Groundwater Application Review Summary Form

Application # G- 18594

TO: Water Rights Section Date 08/30/2018
 FROM: Groundwater Section Darrick E. Boschmann
Reviewer's Name
 SUBJECT: Application G-18594 Supersedes review of N.A.
Date of Review(s)

A. GENERAL INFORMATION: Applicant's Name: Surprise Valley Electrification Corp County: Lake

Figure 15: Interference calculation: LAKE 52530-LAKE 1627 (pumping).

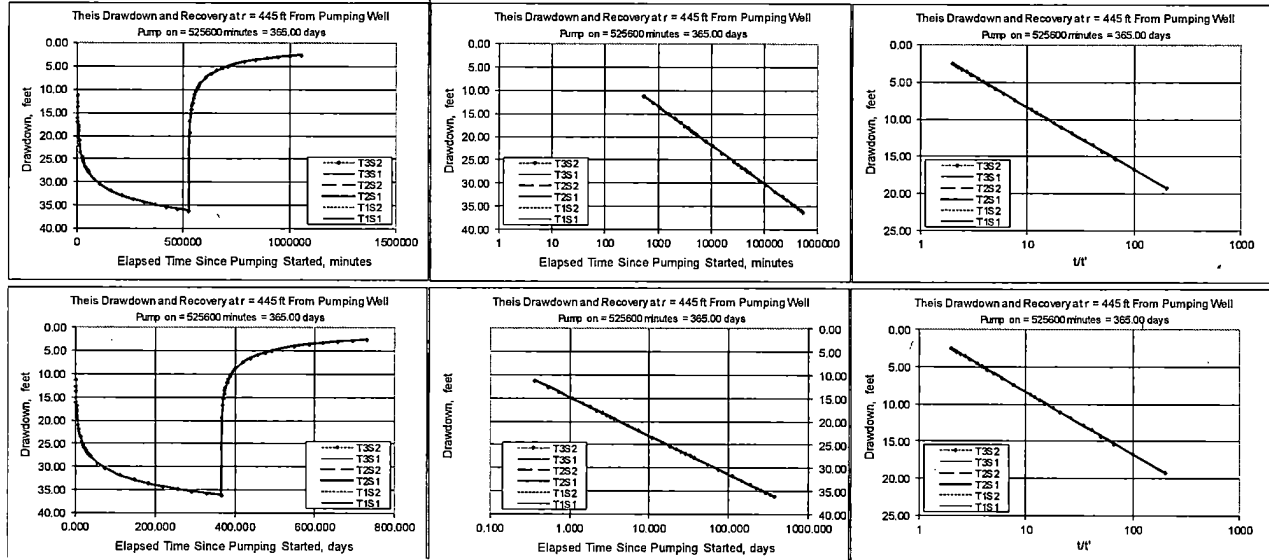
Proposed production well LAKE 52530 is located ~445 feet north of POD 1 under transfer T-11894 (LAKE 1627 "Hot Well"). LAKE 1627 (reconditioning log LAKE 4448) has a reported water temperature of 212 degrees F. The potential increase in interference at LAKE 1627 was calculated using the Theis equation (see attachment). The values for the calculation are conservative and appropriate until better values become available. The calculations use an intermediate storage coefficient (0.001). The transmissivity used in the calculation (5,050 ft²/day [1ft²/day ≈0.37 darcy-ft]) is the transmissivity of the deep geothermal aquifer derived from the Geologica multi-well interference test (report dated 04/19/2018). At the maximum proposed pumping rate for LAKE 52530 (2.67 cfs), the results show an increase in drawdown of ~36 feet after 365* days.

*Note: interference will continue to increase after the 365 day calculated value for this proposed year-round use.

*Note: the interference resulting from a combined pumping rate of 3,000 gpm from both production wells will increase the magnitude of interference at these wells.

Figure 16: Interference Calculation: LAKE 52529-LAKE 1627 (injection).

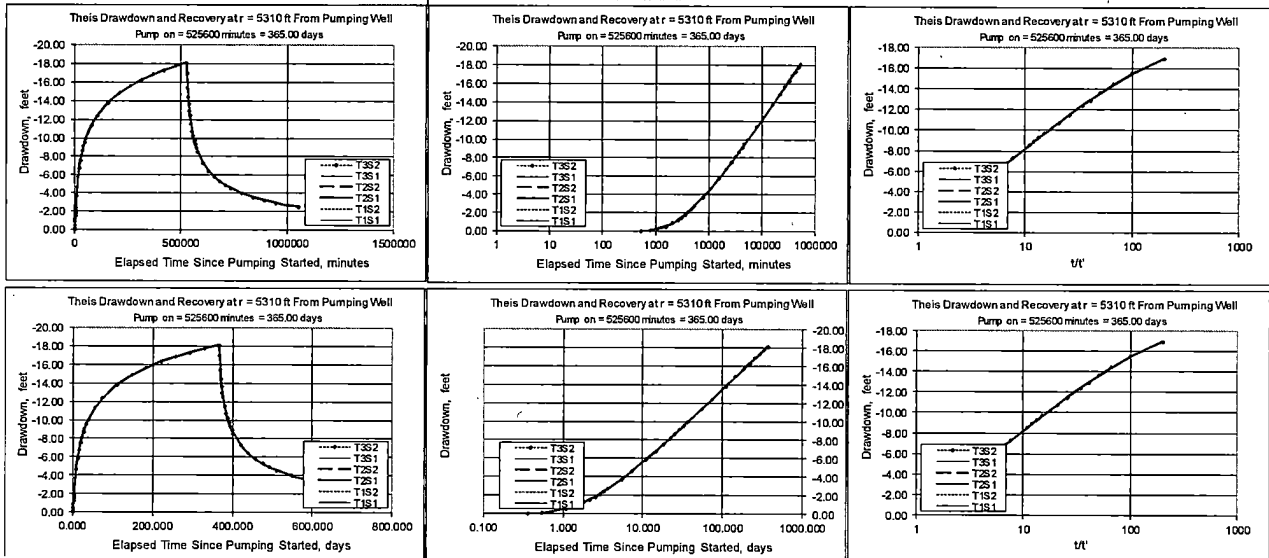
Some degree of relief will be provided by reinjection of produced fluids into LAKE 52812, which is located 5,310 feet northeast of LAKE 1627. The potential decrease in interference at LAKE 1627 resulting from reinjection of fluids produced from LAKE 52530 was calculated using the Theis equation (see attachment). The values for the calculation are conservative and appropriate until better values become available. The calculations use an intermediate storage coefficient (0.001). The transmissivity used in the calculation (5,050 ft²/day [1ft²/day ≈0.37 darcy-ft]) is the transmissivity of the deep geothermal aquifer derived from the Geologica multi-well interference test (report dated 04/19/2018). At the maximum proposed pumping rate for LAKE 52530 (2.67 cfs – reinjected into LAKE 52812), the results show a decrease in drawdown of ~18 feet after 365* days, for a net drawdown of 18 feet, which begins to approach the 25 foot interference limit imposed by condition 7N. See notes below.
